MEMORANDUM

SUBJECT: Loudoun County Public Schools-Lenah Property SPEX 2008-0017 & CMPT 2008-0007

Re: Loudoun County Public Schools – Lenah Property
MS-5 and HS-7
Loudoun County Plan Numbers SPEX 2008-0017 and CMPT 2008-0007

Re: Plan SPEX 2008-0017 / CMPT 08-0007

Figure 4
Existing (2007) AM/PM Peak Hour Traffic Volumes

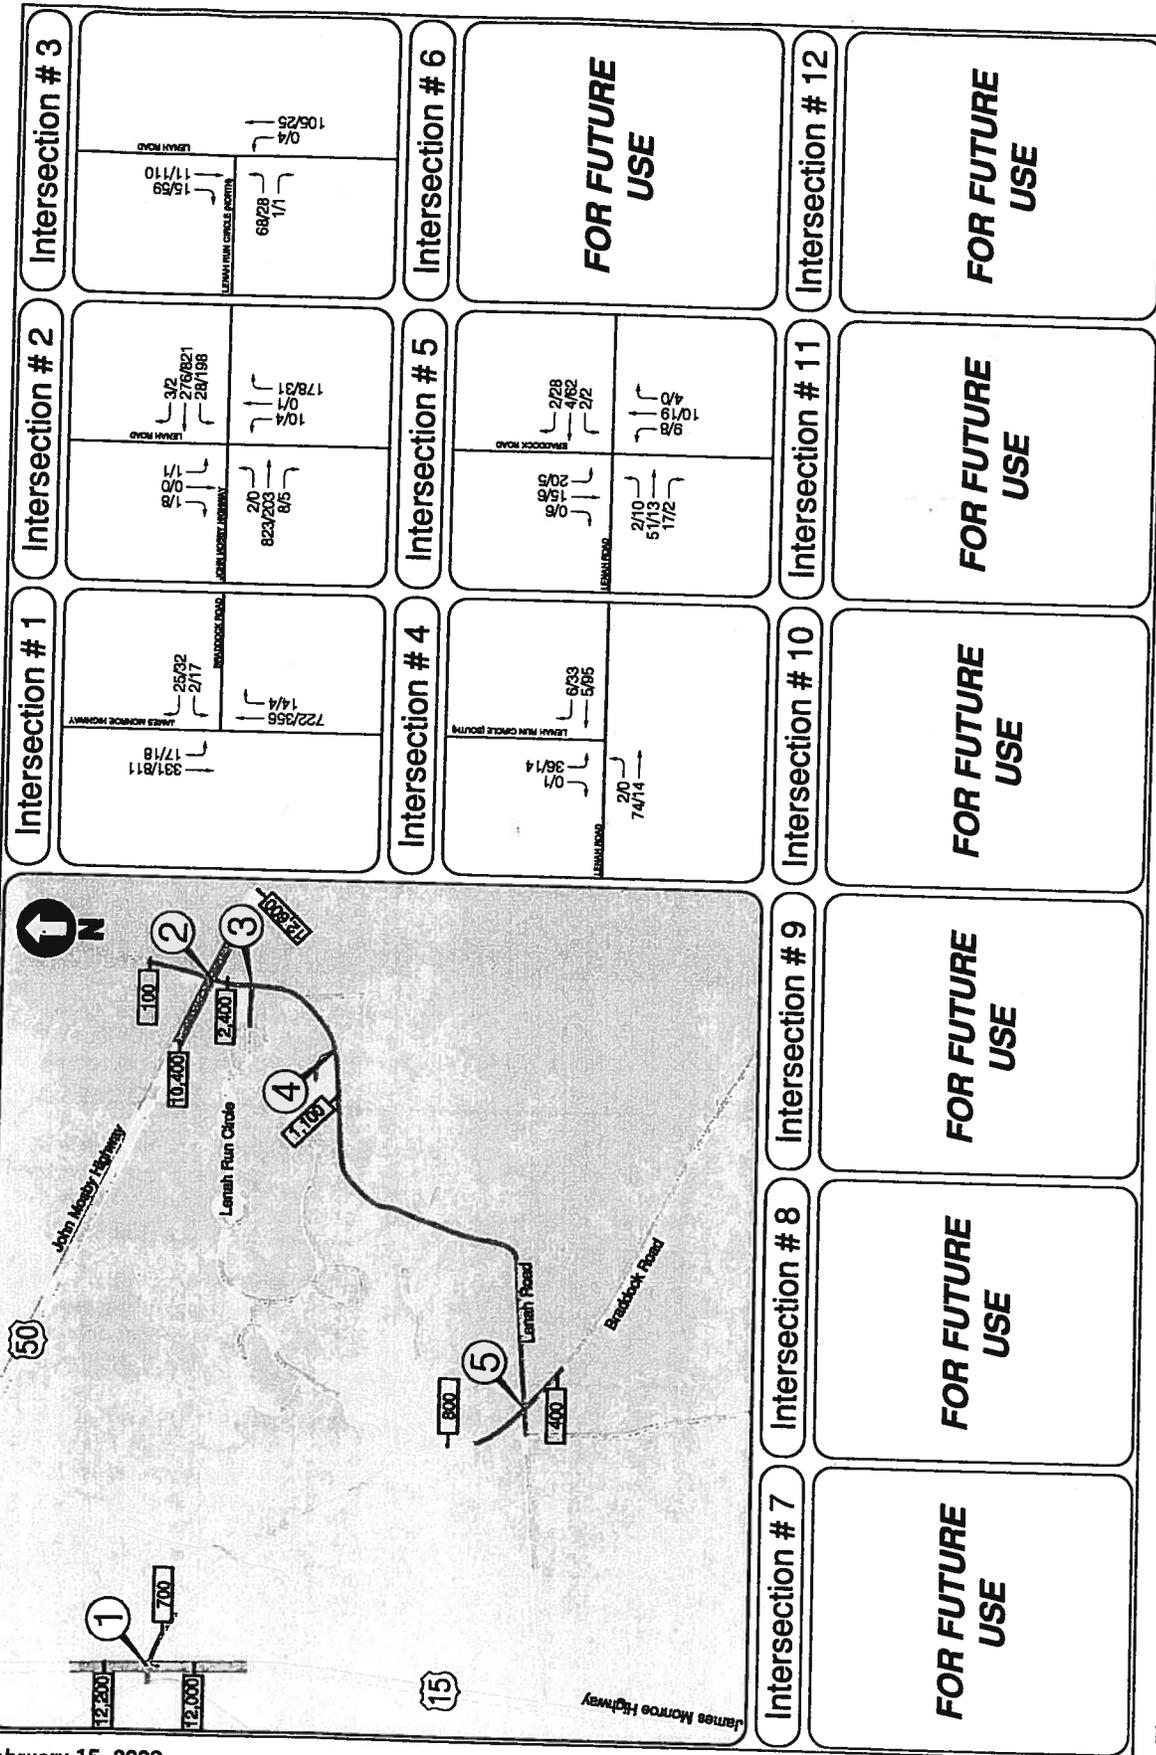
1- Existing counts (2007) at US 50 and Lenah Road seem low. Other studies within vicinity of this study area (Lenah Property submitted by Wells & Associates) are showing higher turning volumes for January 2008 actual counts. Update the existing counts accordingly or provide a set of fresh counts.
